Service Bulletin

Bulletin No.: 18-NA-020

Subject: Malfunction Indicator Lamp Illuminated with DTC P0300 and/or P0299/P2227 Set

4597334

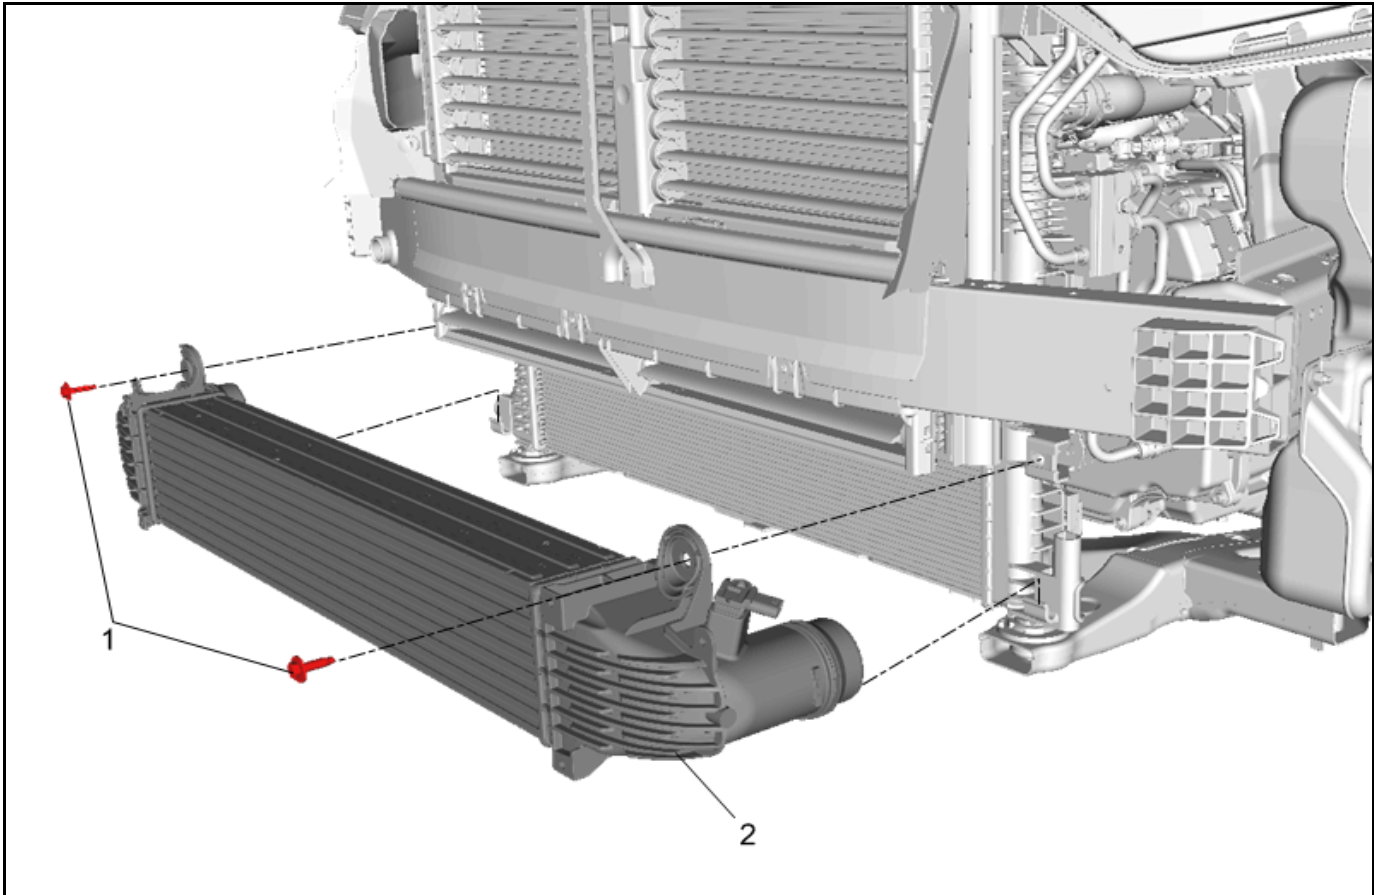
1. Perform a smoke leak test of the charge air cooler.

- If a leak is determined, replace the charge air cooler with the newly designed part. Refer to *Charge Air Cooler Replacement* in SI.
- If there is NO leak, but a P0300, P0299 and/or P2227 are present, **AND the vehicle was built ON or BEFORE March 1, 2018**, then replace the charge air cooler with the newly designed part. Refer to *Charge Air Cooler Replacement* in SI.
- If there is NO leak, but a P0300, P0299 and/or P2227 are present, **AND the vehicle was built AFTER March 1, 2018**, refer to SI for further diagnosis.

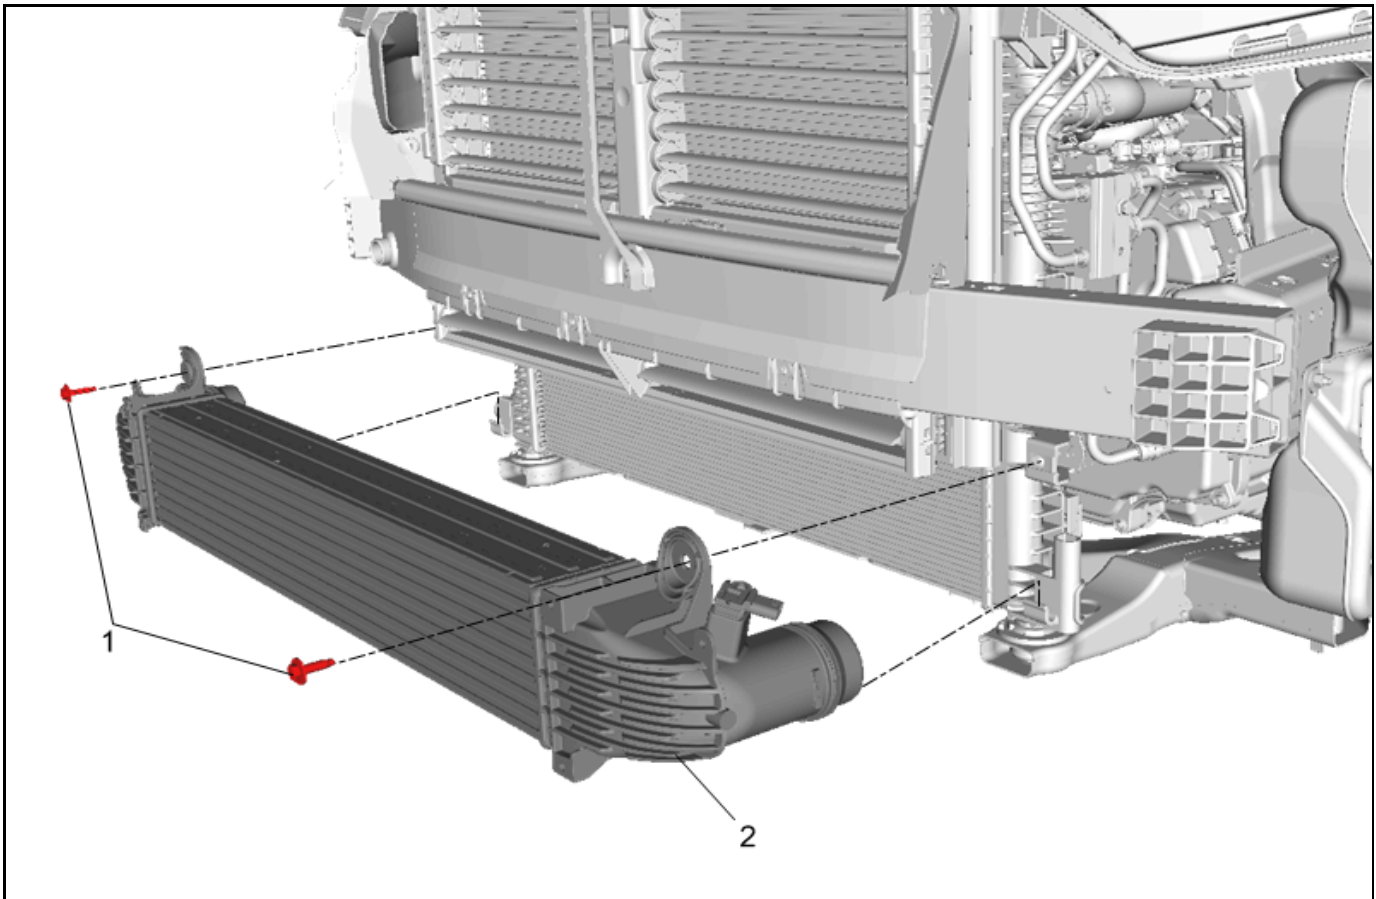
Important: During temperatures ABOVE 32°F / 0°C, the grille cover **MUST** be removed to prevent the engine and transmission from overheating.

The grille cover **MUST** be removed before towing a trailer of any size. Failure to do will decrease the transmission cooling efficiency and possibly cause damage to the drivetrain.

2. If the charge air cooler is icing in cold weather conditions, a grill cover can be installed to help prevent the icing. Give the installation instructions, included with the covers, to the owner for future installations/removals.
